# **Groundwater Application Review Summary Form**

MEM	О	May 10,2019							
то:		Application G- 18660							
FROM:		GW: Joe Kemper (Reviewer's Name)							
SUBJ	ECT: S	cenic Waterway Interference Evaluation							
ď	YES	The course of appropriation is within an above to Cont. W.							
	NO	The source of appropriation is within or above a Scenic Waterway							
Ø	YES	Jse the Scenic Waterway condition (Condition 7J)							
	NO	· · · · · · · · · · · · · · · · · · ·							
<b>1</b>	interfe	RS 390.835, the Groundwater Section is <b>able</b> to calculate ground water brence with surface water that contributes to a Scenic Waterway. The ated interference is distributed below.							
	interfe the De that	RS 390.835, the Groundwater Section is unable to calculate ground water brence with surface water that contributes to a scenic waterway; therefore, epartment is unable to find that there is a preponderance of evidence the proposed use will measurably reduce the surface water flows eary to maintain the free-flowing character of a scenic waterway.

TO:			r Rights S			Date5/10/2019							
FROM	<b>1</b> :	Groui	ndwater S	ection		Joe Ke	mper						
						Revi	ewer's Name	9					
SUBJ	ECT:	`Appli	ca

Figure 3. Summary Statistics for Well Logs for TRS Q 39S/8W-sec 25 NW, sec 26 NE, sec 23 SE, & sec 24 SW.

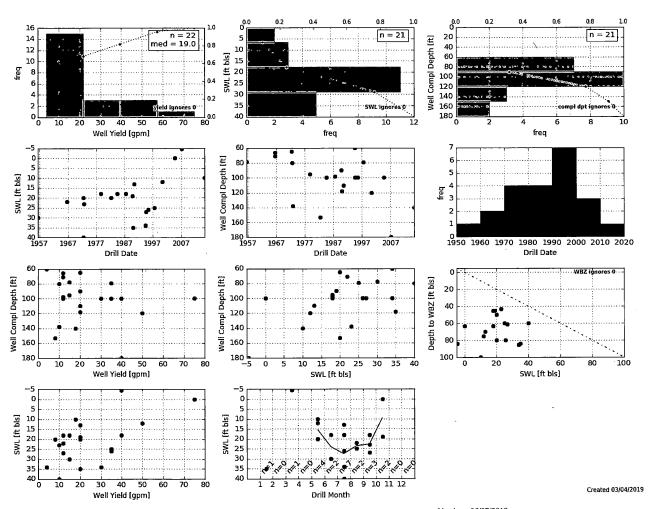
*SWL is assumed to be less than 40 ft BLS, based on report	ted SWLs in well logs for adjacent wells (see Figure 3).
Water Availability Basin the well(s) are located within:
